DART AEROSPACE LTD	Work Order:	132350
Description: Crosstube Assembly, Mid Fwd	Part Number:	D206-667-147
Inspection Dwg: D206-667-147 Rev: A		Page 1 of 2

DART AEROSPACE LTD HAWKESBURY, ONTARIO, CANADA	
DRAWING NO. D206-667-147	REV. A SHEET 1 OF 4
TITLE CROSSTUBE ASS'Y (206L MID FWD)	SCALE NTS
COPYRIGHT © 2010 BY DART AEROSPACE LTD THIS DOCUMENT IS PRIVATE AND CONFIDENTIAL AND IS SUPPLIED ON THE EXPRESS CONDITION THAT IT IS NOT TO BE USED FOR ANY PURPOSE OR COPIED OR COMMUNICATED TO ANY OTHER PERSON WITHOUT WRITTEN PERMISSION FROM DART AEROSPACE LTD.

DRAWING NO. D206-667-147	TITLE CROSSTUBE ASS'Y (206L MID FWD)	REV. A	DART AEROSPACE LTD ENGINEERING ORDER		D.E.O. NO. D206-667-147-A-1	SHEET NO. SHEET 1 OF 1	SCALE NTS
DRAWN 90	CHECKED ASS	MFG. APPR. [Signature]	APPROVED [Signature]		DE APPR. [Signature]		
DATE 11.07.15	DATE 11.07.20	DATE 11.07.21	DATE 11/07/21		DATE 11.07.21

DRAWING NO. D206-667-147	TITLE CROSSTUBE ASS'Y (206L MID FWD)	REV. A	DART AEROSPACE LTD ENGINEERING ORDER	D.E.O. NO. D206-667-147-A-2	SHEET NO. SHEET 1 OF 1	SCALE NTS
DRAWN AJS	CHECKED	MFG APPR	APPROVED	DE APPR		
DATE 12.08.02	DATE 12.08.02	DATE 12.08.02	DATE 12.08.02	DATE 12.08.02	DATE 12.08.02

DETAIL P
BONDING STRAP INSTALLATION 2 PL

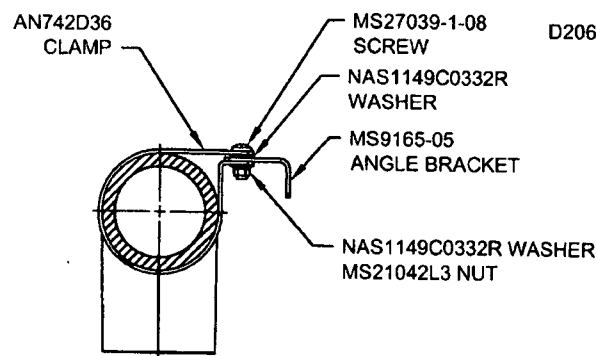
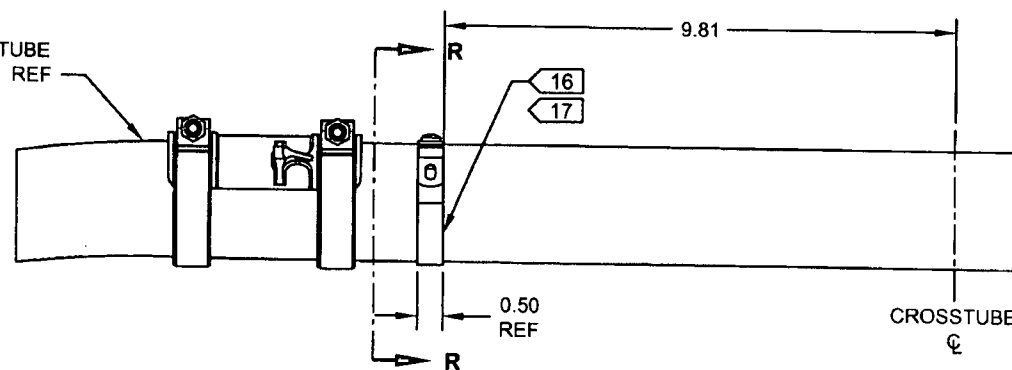
ADD ELECTRICAL GROUNDING STRAP

PARTS LIST:

ITEM	QTY -147	PART NUMBER	DESCRIPTION
1	X	D206-667-147	CROSSTUBE ASSEMBLY (206L MID FWD)
10	2	AN742D36	CLAMP
11	2	MS9165-05	ANGLE BRACKET
12	2	MS21042L3	NUT (OR MS21042-3)
13	2	MS27039-1-08	SCREW
14	4	NAS1149C0332R	WASHER (OR AN960C10L)

- 16) MASK AREA UNDER CLAMP PRIOR TO PAINTING
- 17) SEAL EDGES WHERE AN742D36 CLAMP MEETS WITH THE CROSSTUBE USING SIKAFLEX-241/-291 OR MIL-S-8802 CLASS B2 OR PROSEAL 890 SEALANT
- 18) PERFORM RESISTANCE CHECK TO ENSURE MAX RESISTANCE IS 10 MILLIOHMS
